MKS
INSTRUMENTS

Fax Transmission

Here is the marked-up cable
drawing + the time line from
Luke to Kelly + Fred

REF: LOADLOCK TRANSDUCER

HPS	
Division	ASSY, PIRANI/ATM SWITCH
Division	93-7585 A

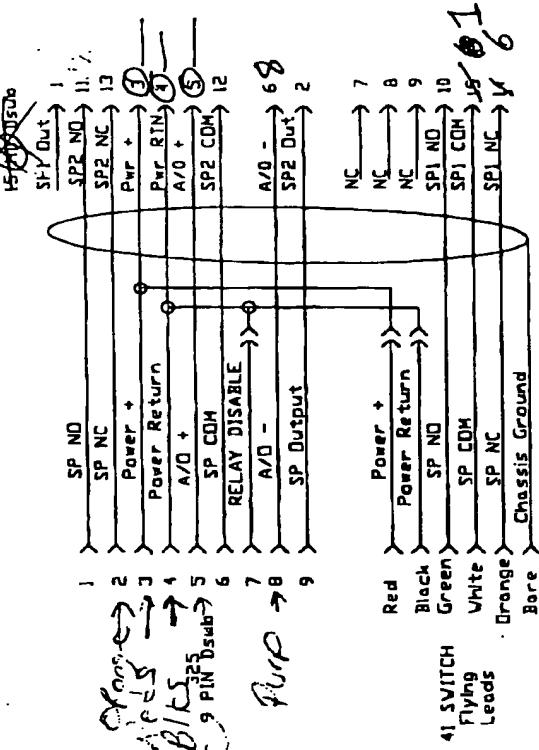
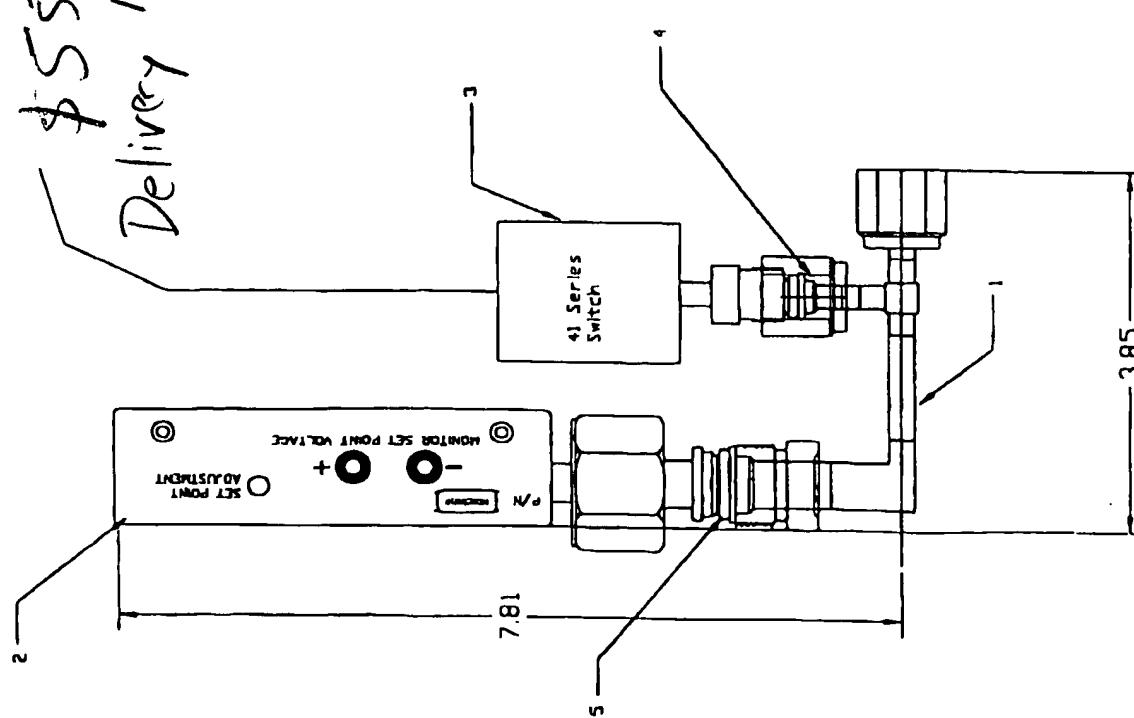
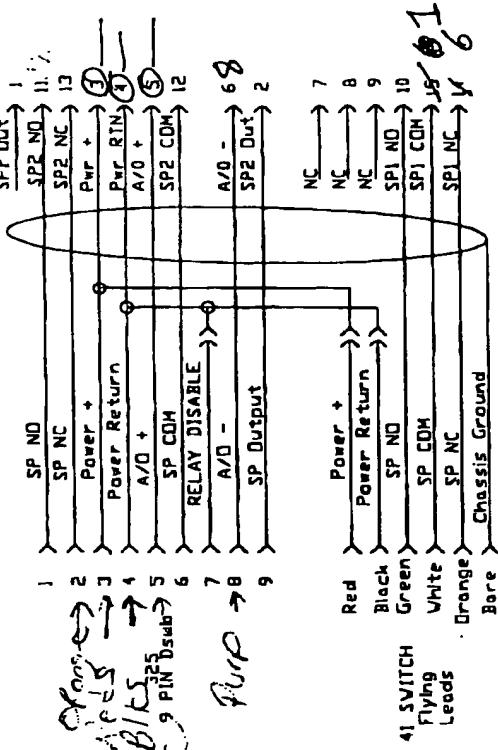
✓ **\$550 each**
✓ **Delivery 11/13/98**
